Item Name: Crosstube Turning Detail

DART AEROSPACE LTD	Work Order: 50703
Description: Crosstube Assembly (205/212/412 Low Fwd)	Part Number: D212-664-147
Inspection Dwg: D212-664-147 Rev: A	Page 1 of 1

A		07.07.07	NEW ISSUE
DESIGN	qp	DRAWN BY	qp
CHECKED		APPROVED	DART
DATE		DART AEROSPACE LTD. HAMPSHIRE, ONTARIO, CANADA	
07.07.07		DRAWING NO. D212-664-147	
THIS DOCUMENT IS PRIVATE AND CONFIDENTIAL AND IS SUPPLIED ON THE EXPRESS CONDITION THAT IT IS NOT TO BE USED FOR ANY PURPOSE OR COPIED OR COMMUNICATED TO ANY OTHER PERSON WITHOUT WRITTEN PERMISSION FROM DART AEROSPACE LTD.		REV. A SHEET 1 OF 3 SCALE CROSSTUBE (205/212/412 LOW FWD) NTS

DRAWING NO. D212-664-147	TITLE CROSSTUBE	REV. A	DART AEROSPACE LTD ENGINEERING ORDER		D.E.O. NO. D212-664-147-A-1	SHEET NO. SHEET 1 OF 1	SCALE NTS
DRAWN <i>JD</i>	CHECKED <i>pt</i>	MFG. APPR. <i>E</i>	APPROVED <i>Ad</i>		DE APPR. <i>th</i>		
DATE 09.05.01	DATE 09.06.15	DATE 09.06.15	DATE 09/06/16		DATE 09/06/16

FIGURE 1 - SUPPORT INSTALLATION

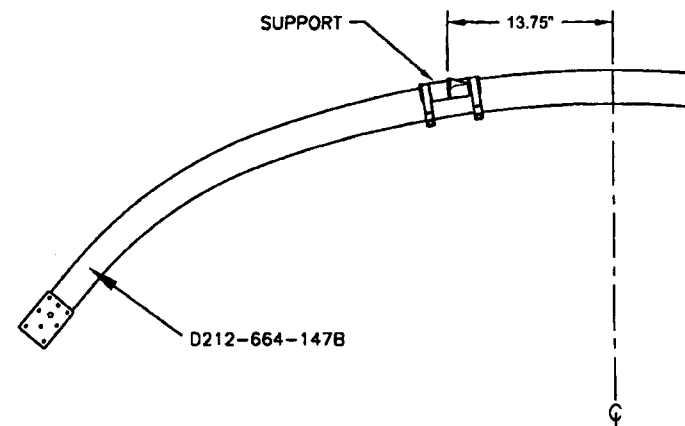
CHANGE:

ADD THE FOLLOWING CROSSTUBE ASSEMBLY:

Part Number	Description
D212-664-147B	CROSSTUBE ASSEMBLY (214 LOW FWD)

THE D212-664-147B CROSSTUBE HAS THE SAME PARTS LIST AS THE D212-664-147 CROSSTUBE. HOWEVER, INSTALL THE SUPPORTS AS SHOWN IN FIGURE 1 OF THIS ENGINEERING ORDER. THE NEW KIT IS OTHERWISE ASSEMBLED PER THE D212-664-147 CROSSTUBE.
